# SERVICE SLANTS

ISSUED BY WURLITZER SERVICE DEPT., NORTH TONAWANDA, N. Y.

SUBJECT: Modification of Automatic Level Control Model 528 H.F. Amplifier.

Modification of Automatic Level Control Model 528 Amplifier

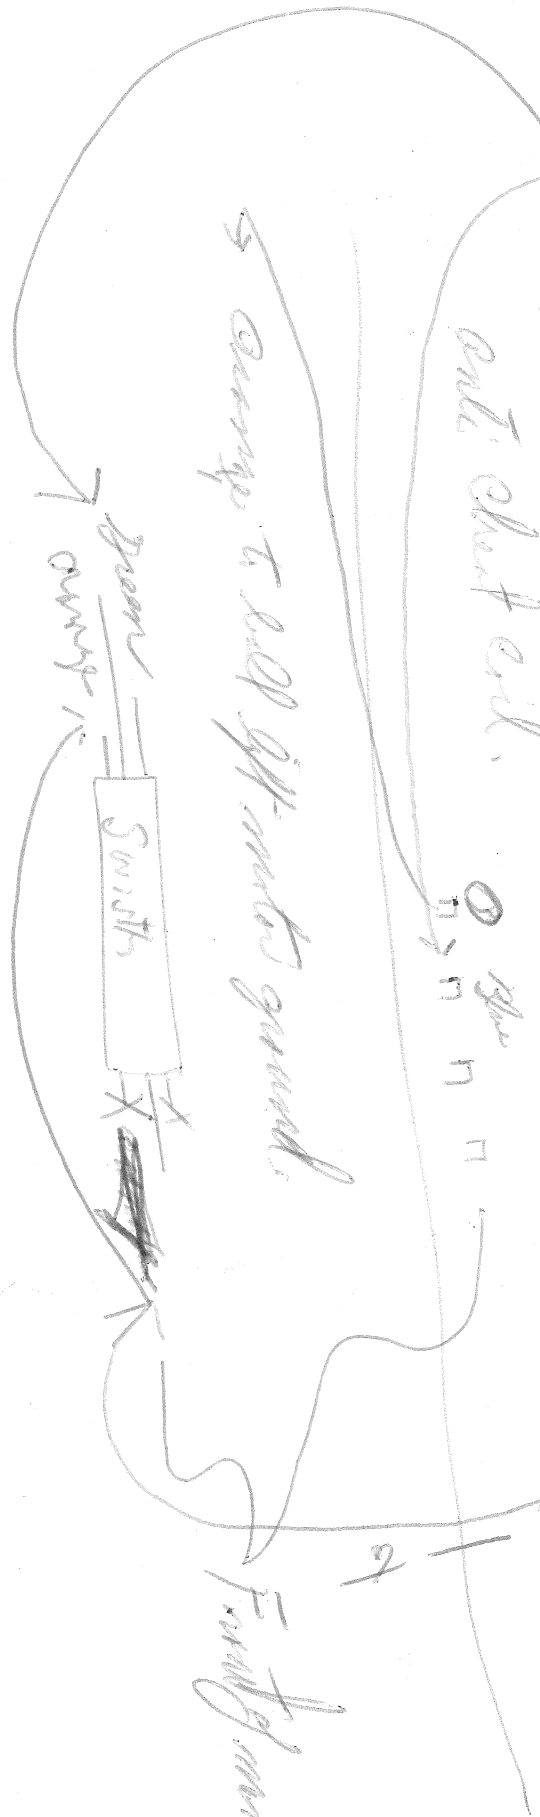
To reduce the high initial volume effect from some amplifiers, which may occur after the phonograph has been (standing by) for a considerable length of time and then put into play in one of its shortest time cycles, the following modification has been adopted:

1. After wiring changes in the "Time Constant" circuit, as indicated in the sketch below, have been completed, R-17 may be changed as desired from 68K to any where between 82 and 100K. The position of R-17 is indicated in the sketch.
